Intel[®] Pentium[®] III Processor Specification Update

Release Date: April 2005

Document Number: 244453-054

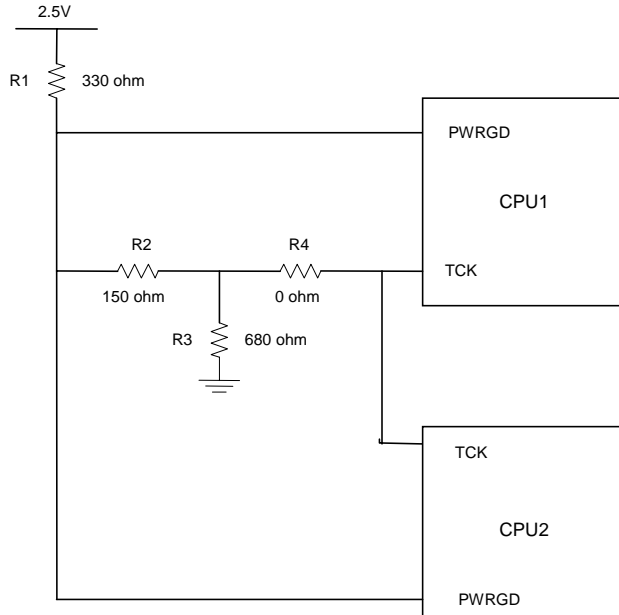
Problem: The internal control register bit responsible for operation of the Thermtrip circuit functionality may power up in a non-initialized state. As a result, THERMTRIP# may be incorrectly asserted during de-assertion of RESET# at nominal operating temperatures. When THERMTRIP# is asserted as a result of this erratum, the processor may shut down internally and stop execution but in few cases continue to execute.

Implication: This issue can lead to intermittent system power-on boot failures. The occurrence and repeatability of failures is system dependent, however all systems and processors are susceptible to failure. In addition, the processor may fail to stop execution during the event of a valid THERMTRIP# assertion resulting in the potential for permanent processor damage.

Workaround: To prevent the risk of power-on boot failures or catastrophic thermal failures, a platform workaround is required. The system must provide a rising edge on the TCK signal during the power-on sequence that meets all of the following requirements:

- Rising edge occurs after Vcc_core is valid and stable
- Rising edge occurs before or at the de-assertion of RESET#
- Rising edge occurs after all Vref input signals are at valid voltage levels
- TCK input meets the Vih min and max spec as mentioned in EMTS
